**CITY OF KOKOMO
HOWARD COUNTY, INDIANA**

NORTH SIDE INTERCEPTOR RELIEF SEWER

Addendum No. 2

April 22, 2024

PAVEMENT RESTORATION MAP

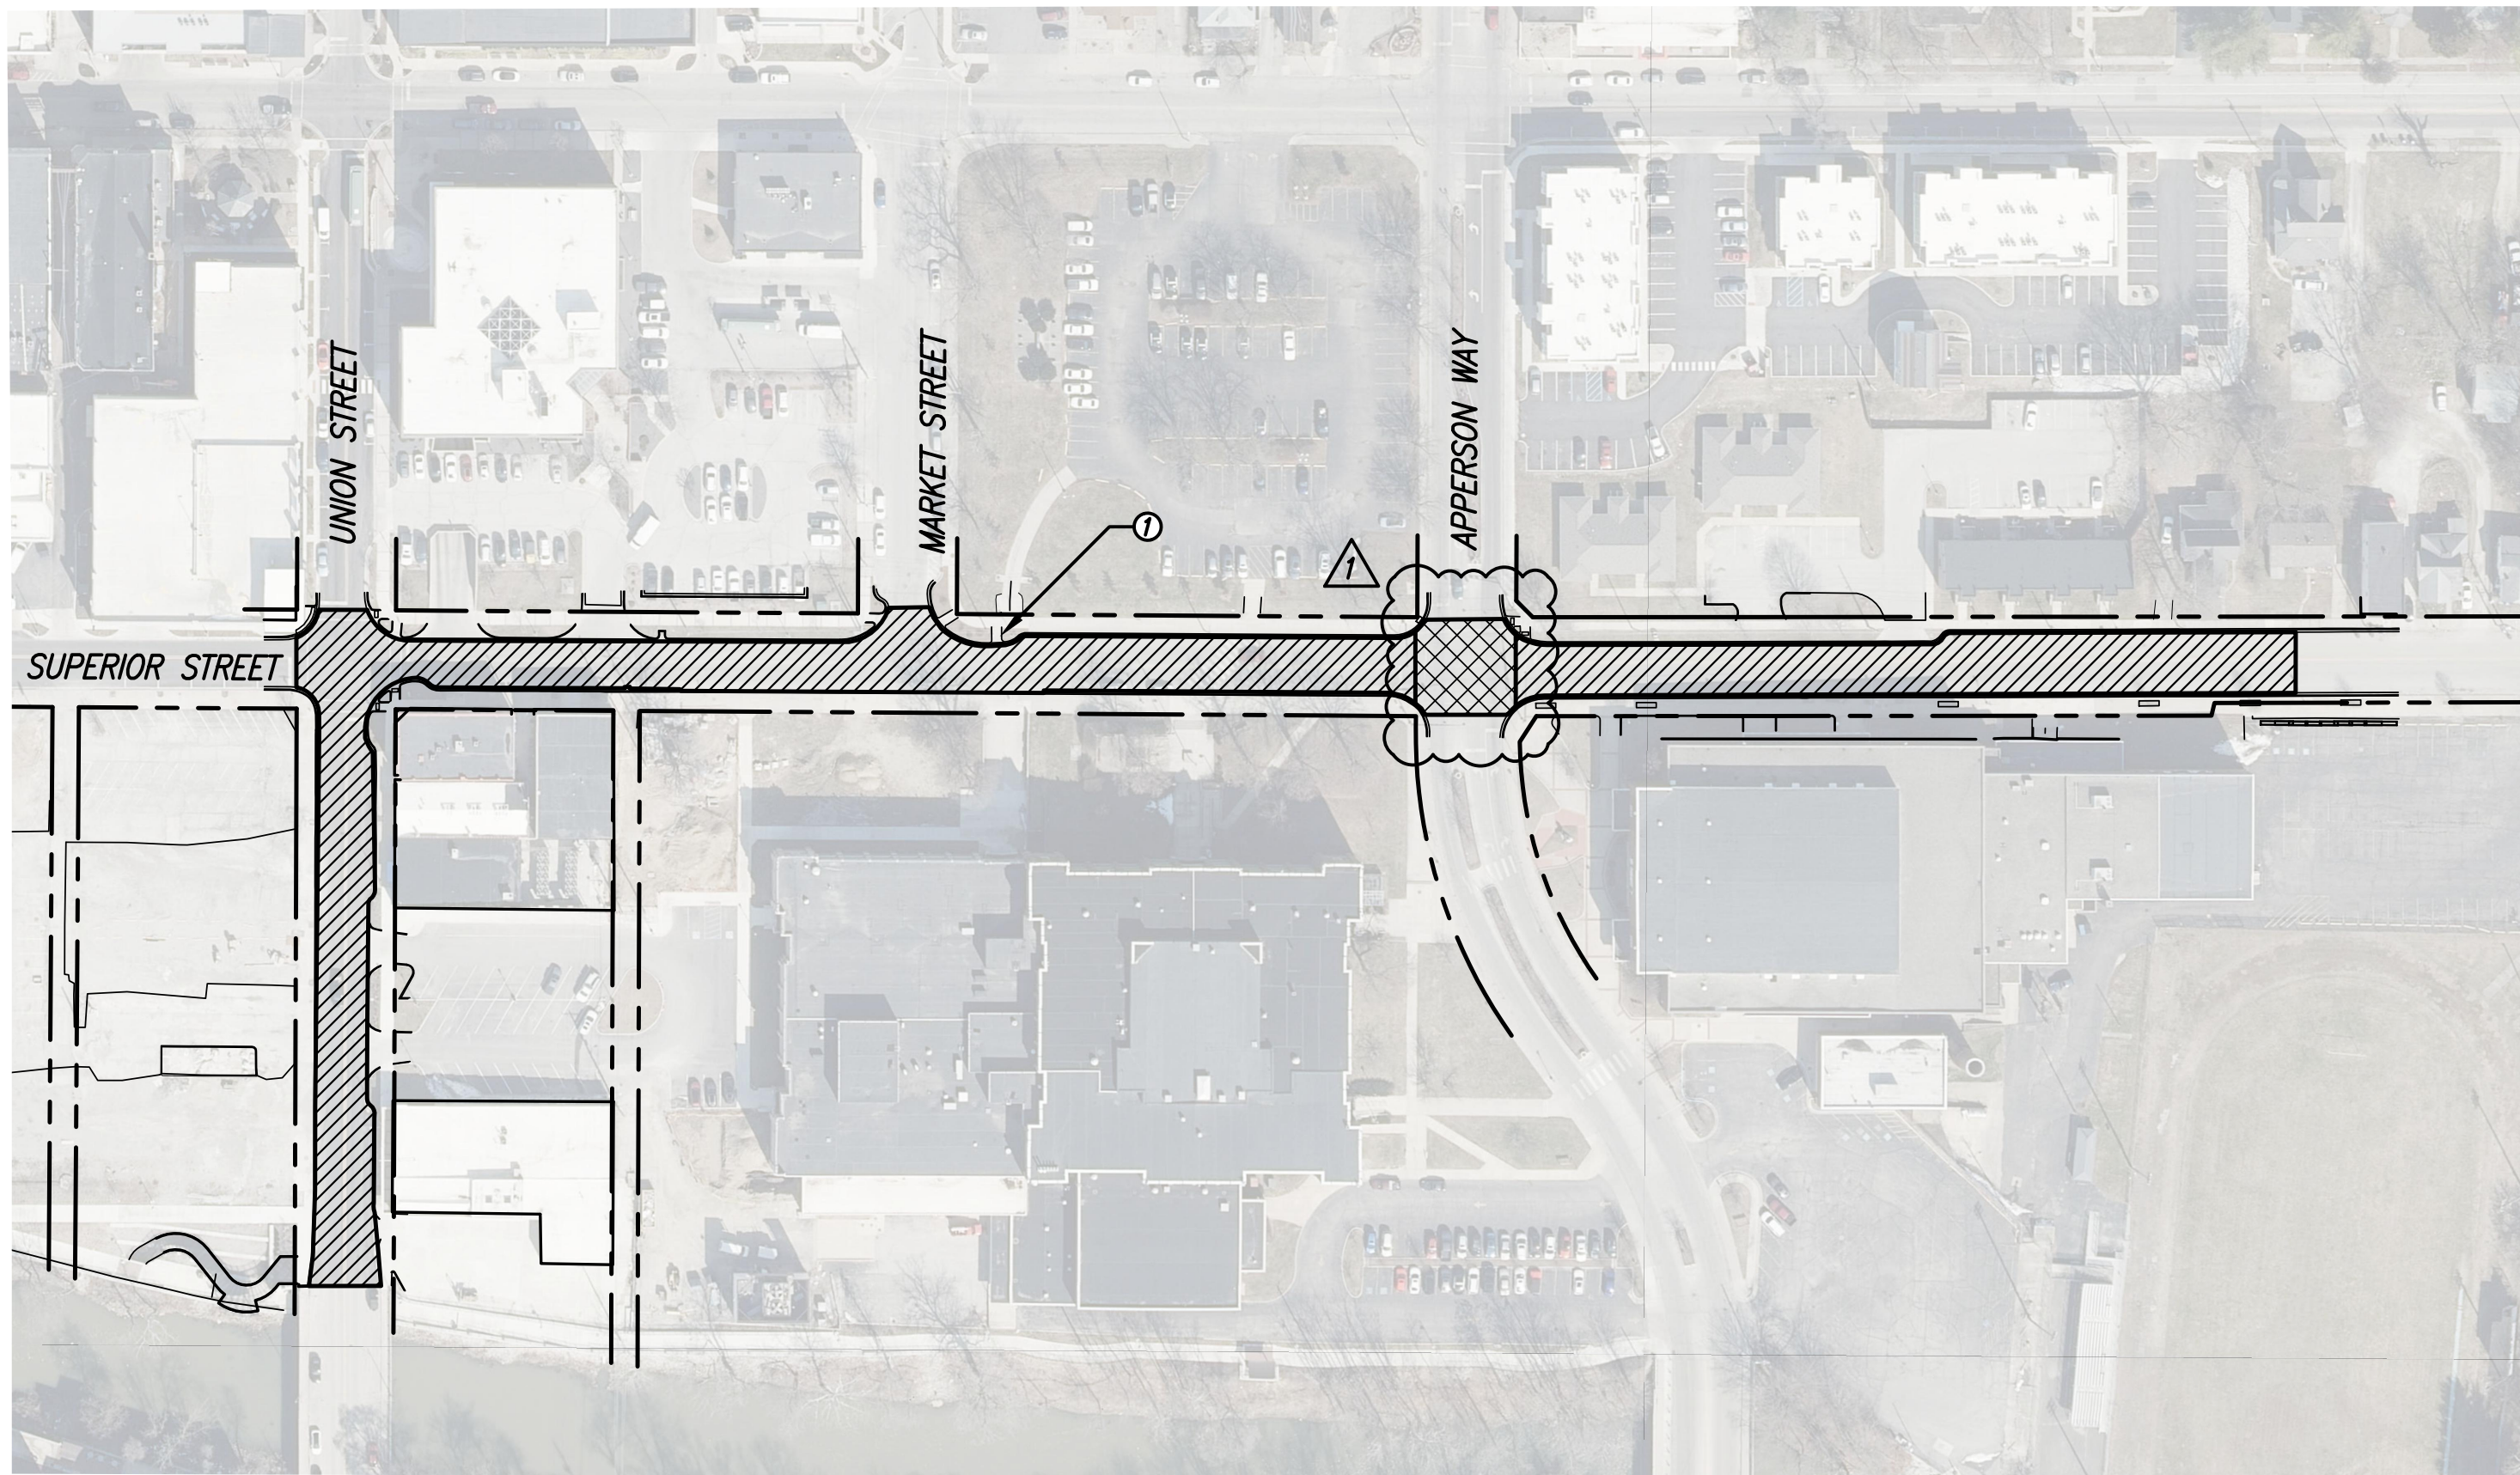
Item No. 2: Revision – Plan Sheet 7 has been revised to distinguish between HMA Pavement “Heavy Base” and “Standard Base”. The Pavement Restoration Map has been updated and a detail for Typical Asphalt Street Restoration Detail (Heavy Base) has been added. Revisions have been clouded accordingly on the plan sheet.

TYPICAL ASPHALT STREET RESTORATION DETAIL (HEAVY BASE)
NOT TO SCALE

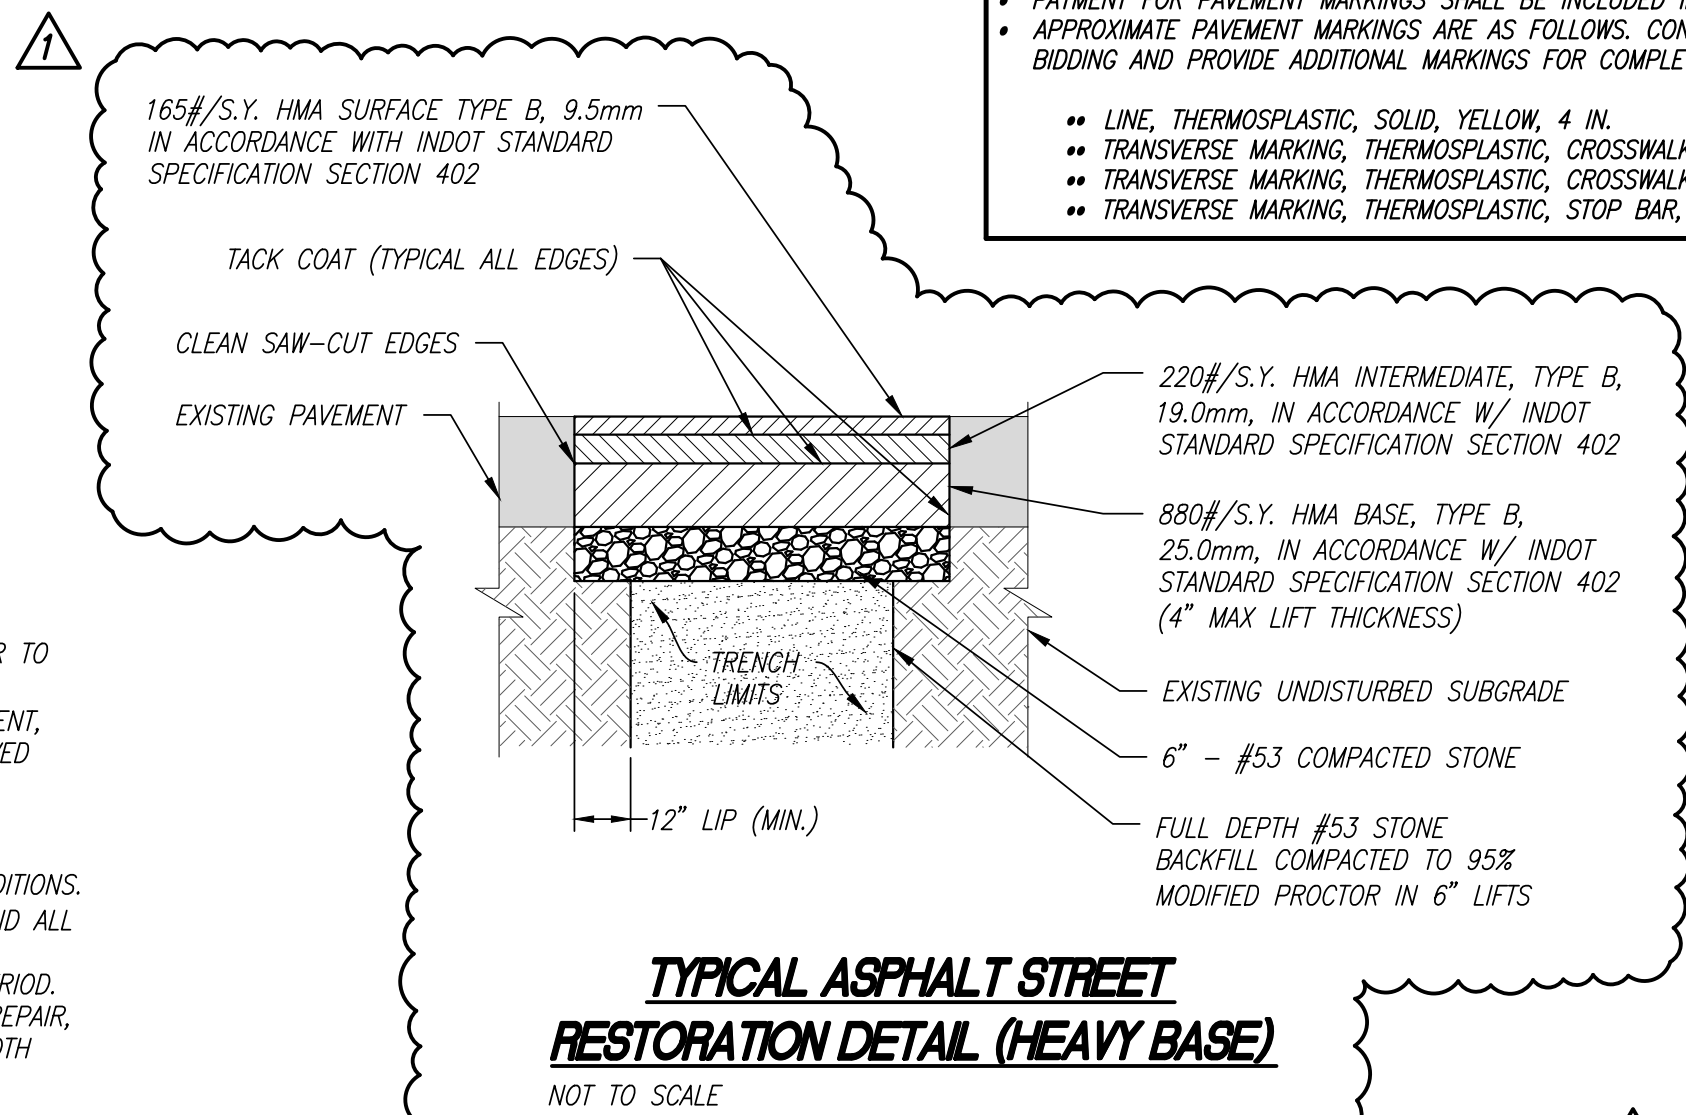
ADDED "HEAVY BASE" PAVEMENT SECTION FOR APPERSON WAY PER ADDENDUM #2 APRIL 22, 2024
